Service Bulletin

AR14H Vibratory Ride-On Roller

Water Pump Protective Rubber Flap

Product Group: Roller	Date Issued: 08/09/16	Service Bulletin No. RR20160804
Bulletin Type <input type="checkbox"/> Mandatory <input type="checkbox"/> Information Only <input checked="" type="checkbox"/> Recommended Change	Models/Series Affected: AR14H S/N 160700 — AND BELOW

Figure 1. Water Pump Rubber Flap Protector Installation

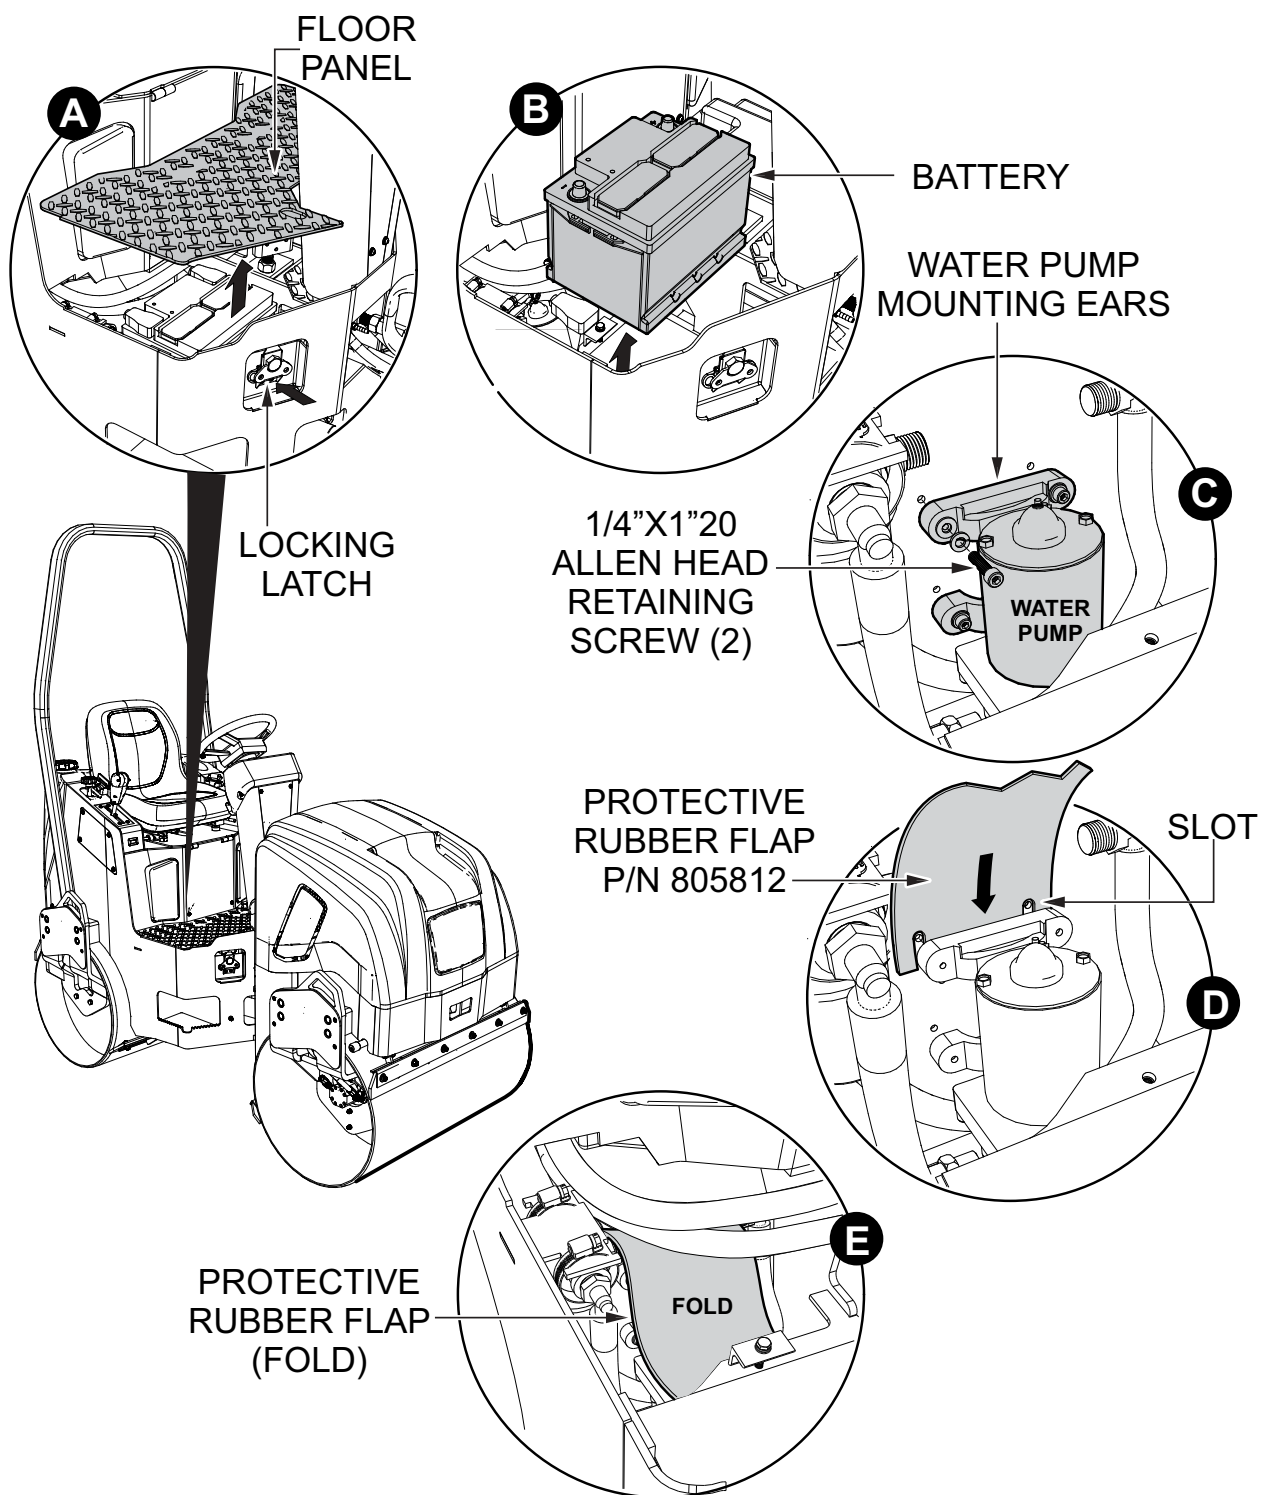
Details
Problems: a. Water is entering the compartment where the water pump is located. This condition can cause the electrical motor inside the pump and associated wiring to short out. Solutions: a. Install a protective rubber flap to protect the water pump from water.

1. Release the latch (Figure 1A) that secures the floor panel to the frame.
2. Next, remove the battery (Figure 1B) from the roller and set aside in a safe place. Remove the **negative** battery cable first.
3. Using a 3/16" allen wrench remove the two 1/4" X 1" 20 allen head screws (Figure 1C) and associated hardware that secure the water pump to the frame.
4. Place the sloted sections (Figure 1D) on the protective rubber flap over the pump mounting holes.
5. Reinstall the pump mounting ears (Figure 1D) on top of the protective rubber flap and secure with hardware that was removed in step 3.
6. Fold the protective rubber flap over the pump to protect it from water (Figure 1E).
7. Reinstall the battery. Connect the **positive** battery cable first.
8. Reinstall floor panel and secure with locking latch.
